Review of Hydrologic Impacts Of the Proposed Stibnite Gold Project Draft Environmental Impact Statement (DEIS) August 2020

September 16, 2020

Prepared by
Robert H. Prucha, Phd, PE
Integrated Hydro Systems, LLC
Boulder, Colorado

Figure 1. SGP Modeling Process and Analysis Tools (B&C, 2018 Existing Conditions Study)

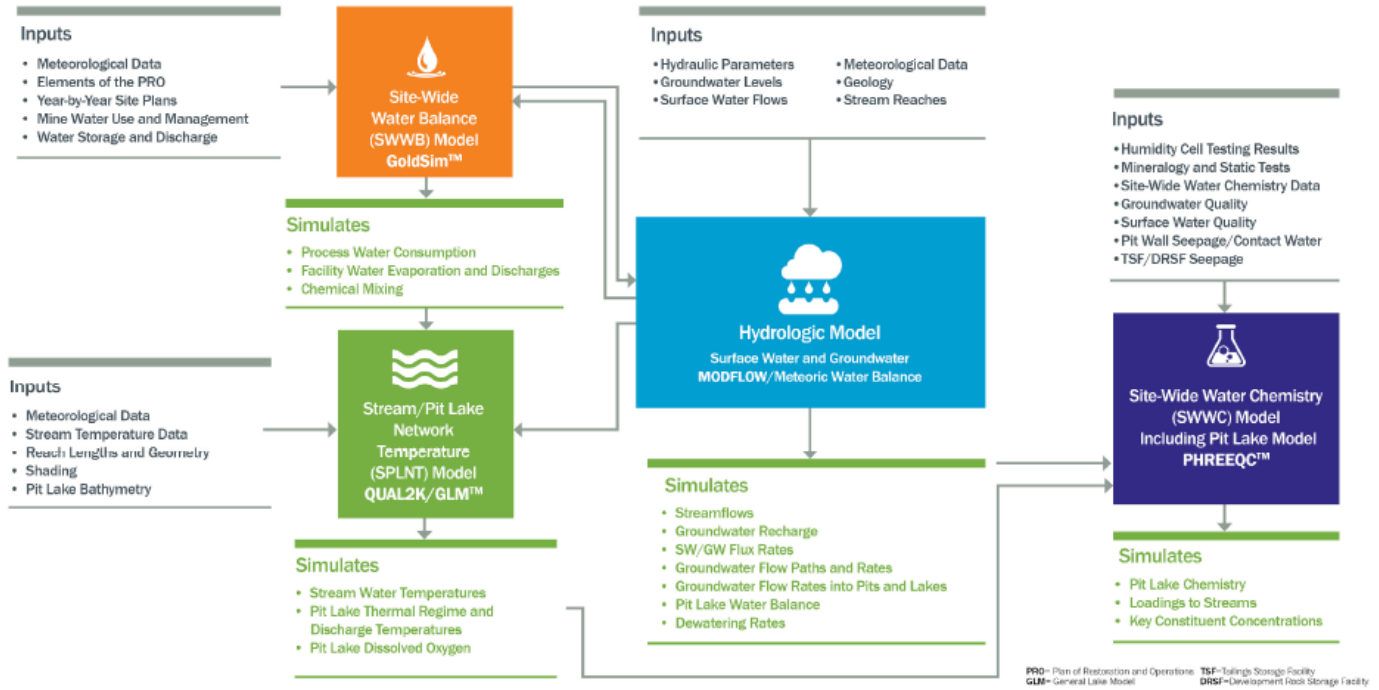
A general 'industry-standard' approach for developing and applying appropriate models to assess hydrologic impacts is lacking in the DEIS, despite B&C presenting a general flow chart (Figure 1) showing how model inputs and outputs are shared across all tools used to assess existing and mine-impacted conditions. A general modeling approach used to develop predictions via use of numerical models was never presented. For my assessment, I reviewed all relevant hydro-related DEIS documents for deficiencies/problems following various modeling steps following the industry

Figure 3. Figure 2 from App D in 2016 SGP Plan of Restoration and Operations, page D-8.

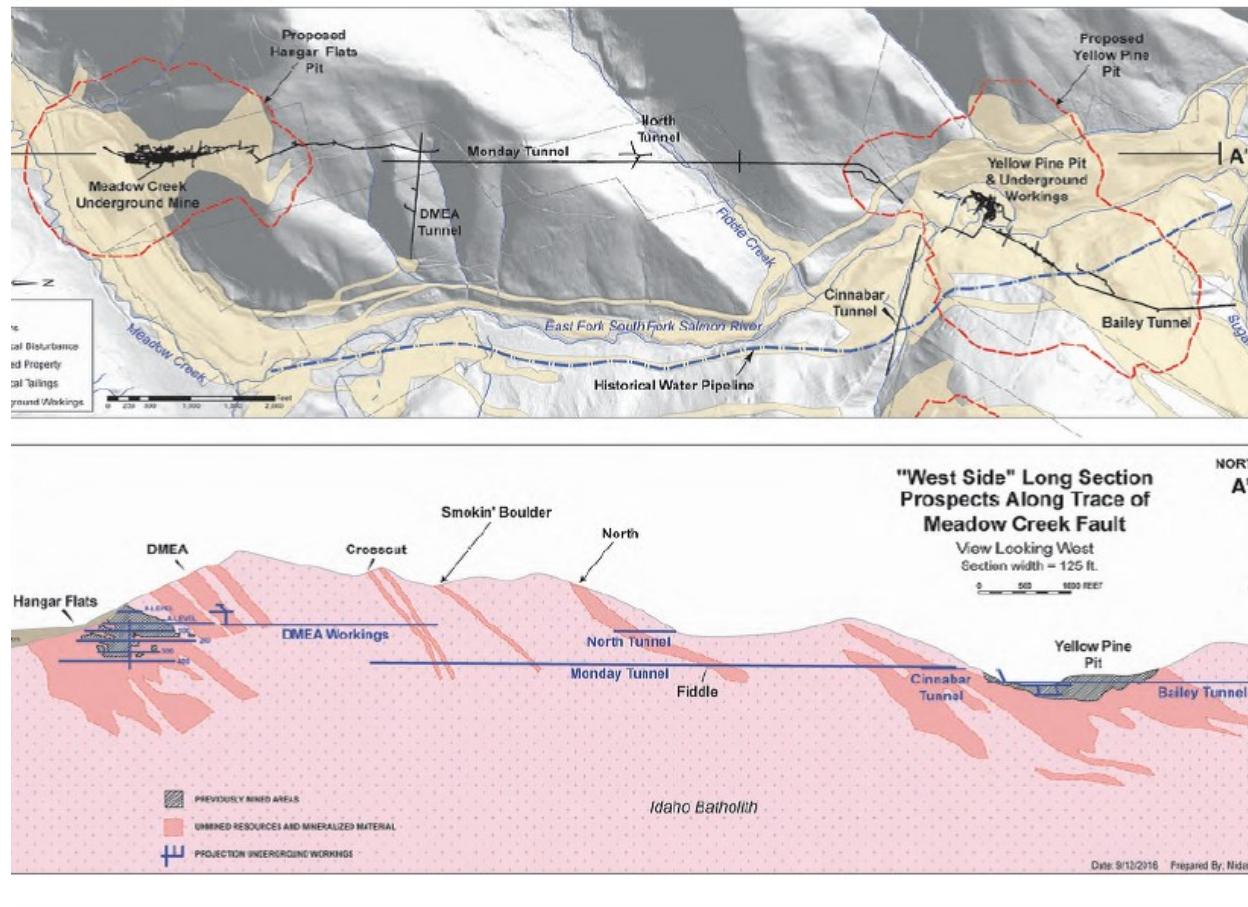
The Plan of Restoration and Operation – Appendix D (2016 SGP Plan of Restoration and Operations, page D-8) shows a cross-section (Figure 2) on Figure 3. This figure indicates substantial underground workings and interconnected tunnels extending from higher elevation

Figure 4. Figure 9-1 from B&C 2017 SGP Water Resources Summary report.

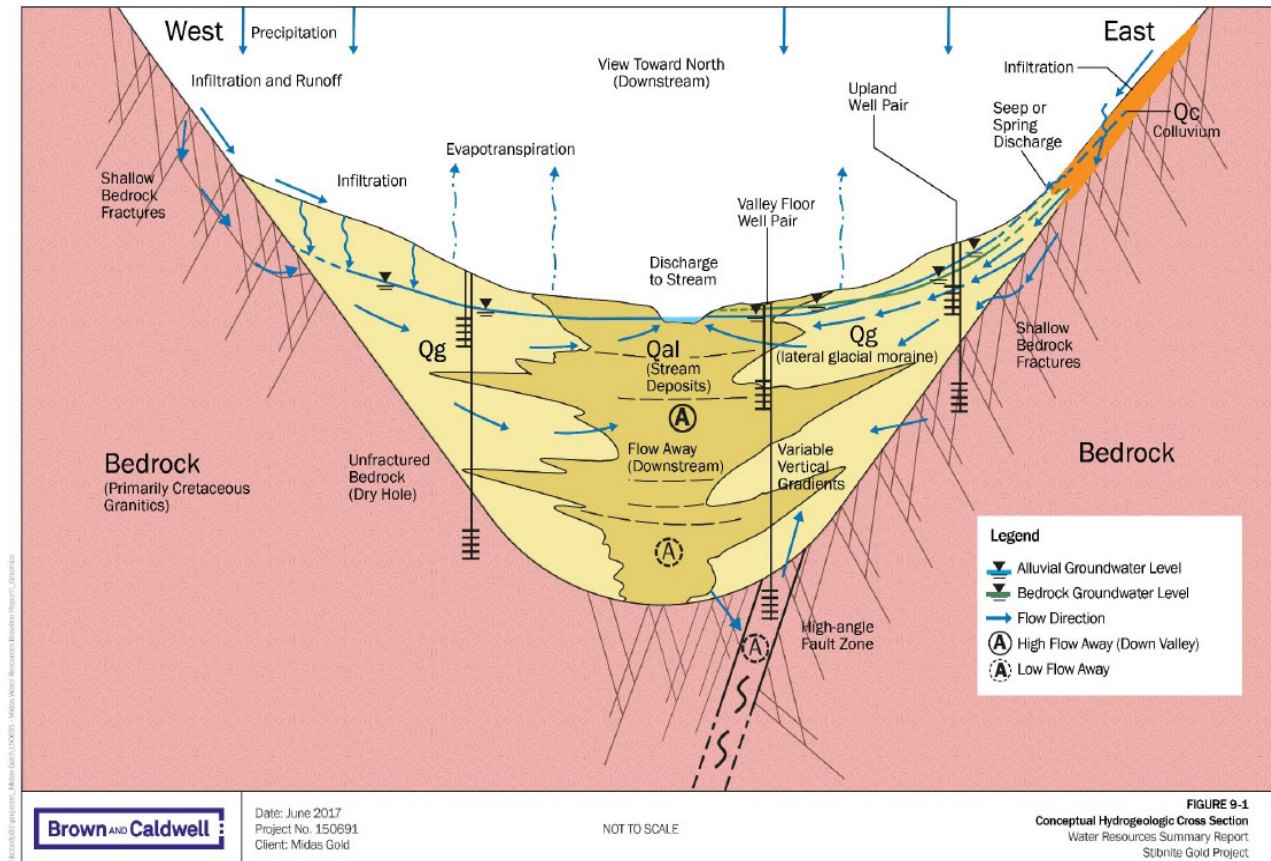
- Another example is that upland areas shown on the conceptual 2D section show shallow bedrock fractures, yet the EC model assumes that bedrock is fractured (and therefore more permeable) only beneath all streams, and arbitrarily assumed to be 500 ft thick.
- Within the thicker valley fill areas (i.e., Meadow Creek near Hangar Flats), even surficial geologic mapping shows Qal stream alluvium embedded within broader Glacial Deposits (Qg), where Qal exhibits greater silts, or lower permeabilities (at least vertically). Yet the EC model lumps the entire 'overburden' into a single layer. Further, the EC model fails to consider hydraulic property variations, such as between Qc (colluvium) and adjacent Qg materials, where their conceptualization shows seeps/springs occur.

Figure 4 (Figure 9-1 from B&C 2017 SGP Water Resources Summary report, page 9-3) indicates the flow conceptualization exhibits some flaws:

- Why is ET only shown in valley sediment? It also occurs on hillslopes and is not insignificant.
- Given the high degree of complexity in the subsurface over the mine footprint, a realistic range of alternative conceptual models should have been considered in the modeling to account for substantial uncertainty in virtually all model input. Conceptual model uncertainty typically accounts for most uncertainty in subsequent numerical model predictions. Neuman and Weiranga, 2003⁹ describe in detail how to incorporate alternative conceptual models into formal uncertainty analyses. Typically, conceptual model uncertainty dominates overall predictive uncertainty and as such should have been more fully assessed in the DEIS modeling evaluations.

Figure 6. Generalized Subsurface Layering and Hydraulic Property Zones in B&C 2018 Existing Conditions modeling study.

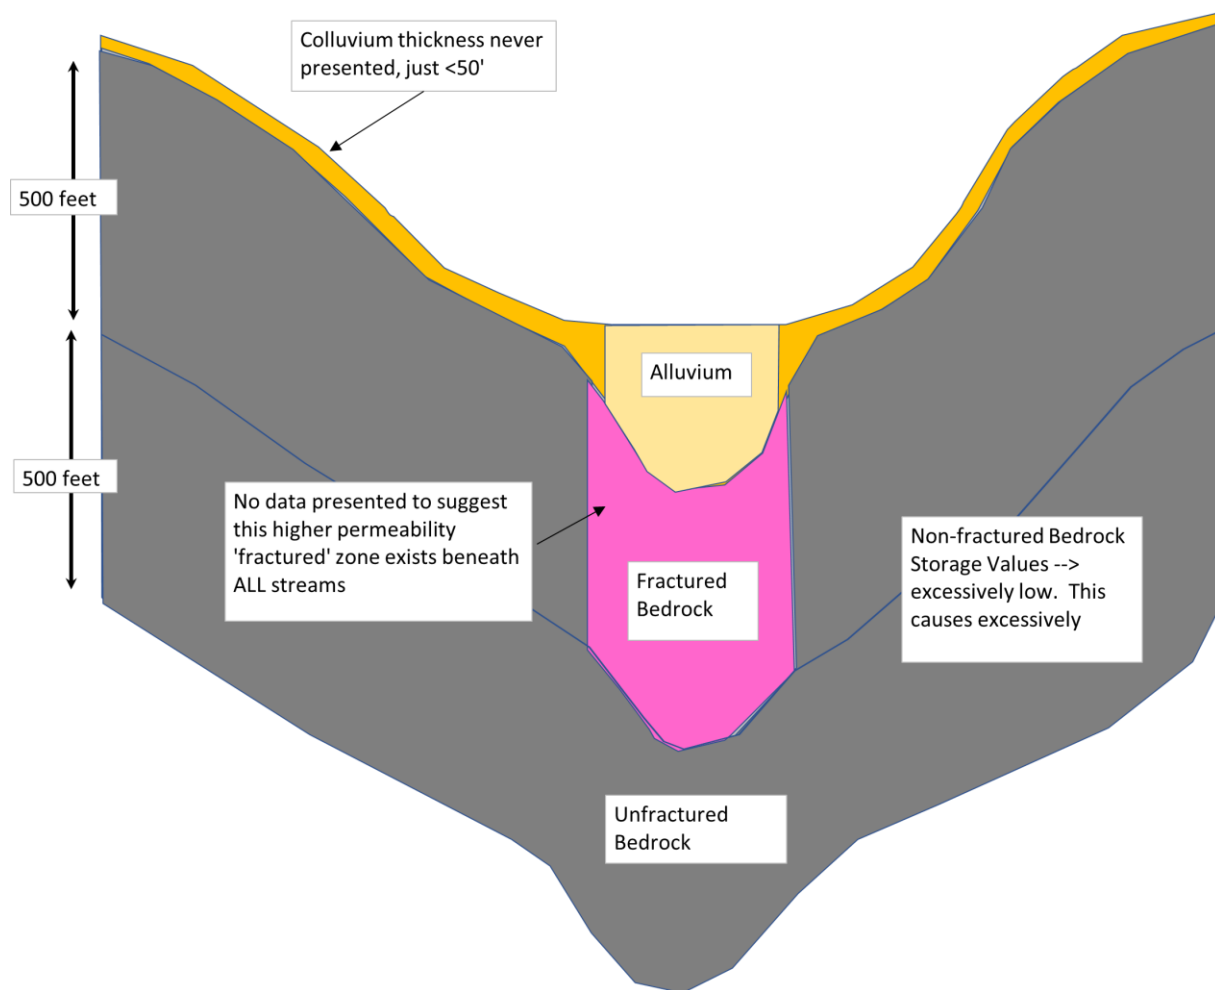
- Figure 6 shows relatively high K specified in bedrock below ALL stream areas within the model. This is very unrealistic and no justification or data provided to support this specification.
- Storage coefficient – 1×10^{-7} 1/ft is incorrect (Table 4-2 in B&C 2018 EC model study), and should instead be a very low number. B&C 2018 EC digital MODFLOW model file inputs indicates it is actually specified as 1×10^{-7} 1/ft. However, this number still appears to be unrealistically low by 1 to 2 orders of magnitude. **A key issue with specifying such a low storage number, is that it directly and notably affects estimated mine impacts, such as total pit dewatering/pitlake fill rates and times, timing/magnitude of impacts to wetlands/streams/GDEs, RIB performance etc.**

Figure 9. Proposed restoration area of Blowout Creek. Green lines represent Meadow Creek Fault Zone.

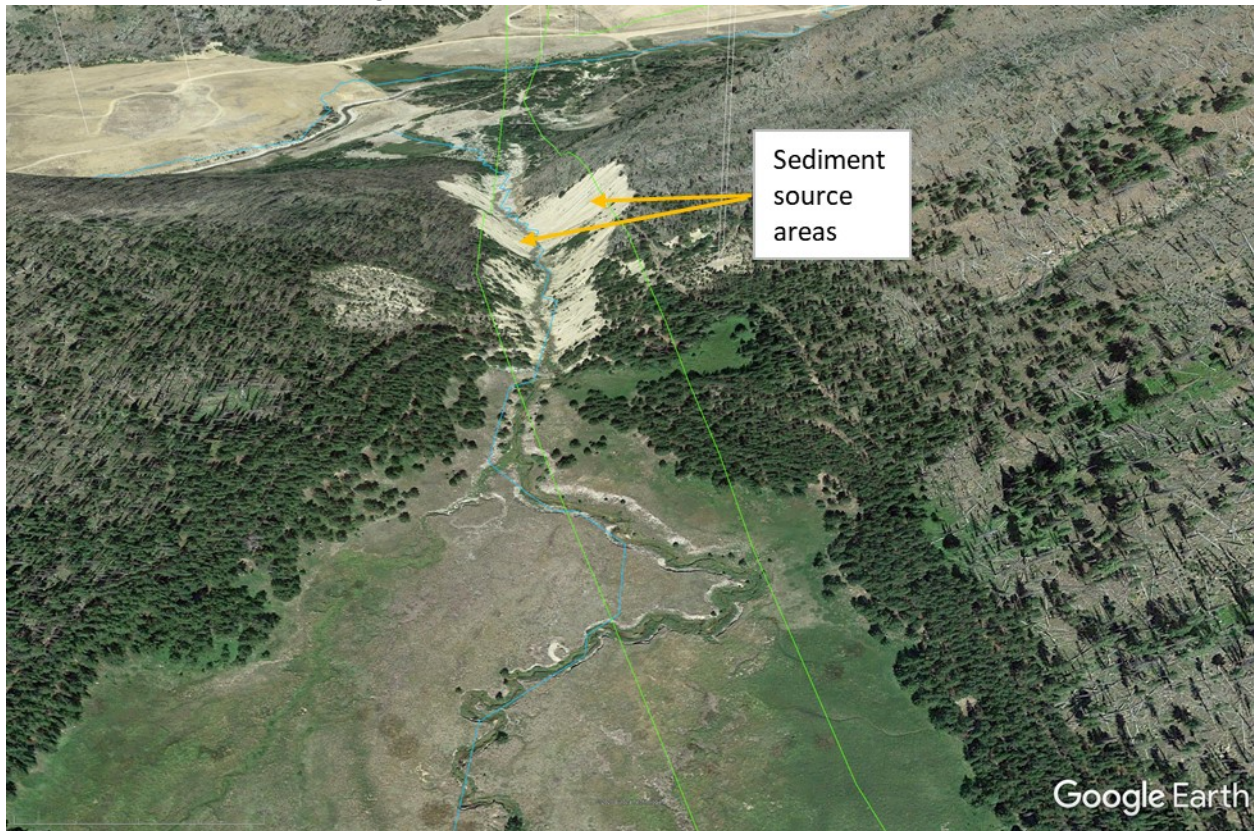
- Visual examination of this area in Google Earth (see Figure 9) strongly suggests the main source of sediment are the exposed sides of the drainage as shown, which are generating rills/gullies. In addition, these appear to be bounded by the trace of the Meadow Creek Fault Zone (two green lines mapped by Stewart et al, 2016¹⁶).

- include surface water diversions above upper top of slopes along exposed slopes to account for future post-fire flooding in the area, which would only further degrade the area.
